21-VARIANCE-0113

Barret Avenue Variance

Louisville Metro Board of Zoning Adjustment
Public Hearing

Heather Pollock, Planner I
September 13, 2021

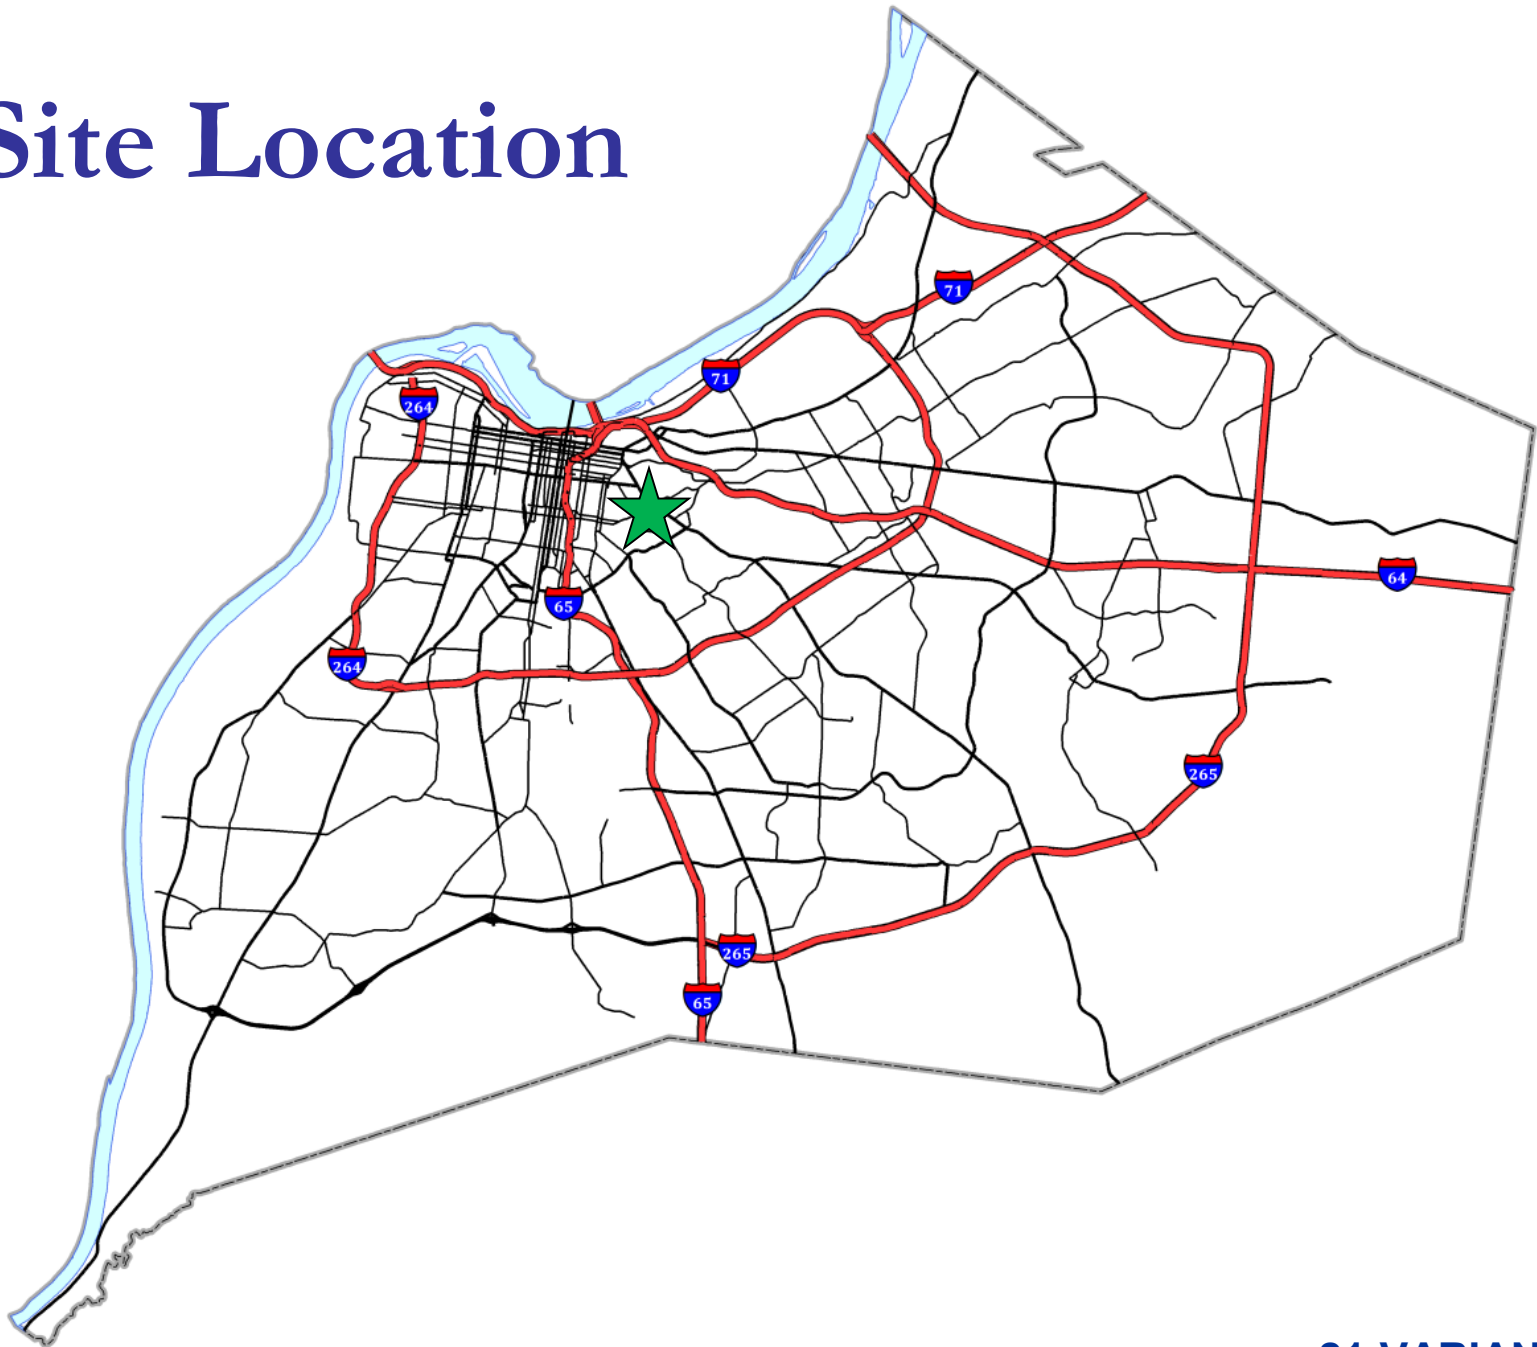
- **Variance:** from Land Development Code table 5.2.2 to allow a principal structure to encroach into the side yard setback.

Location	Requirement	Request	Variance
Side Yard	2.5 ft.	1.07 ft.	1.43 ft.
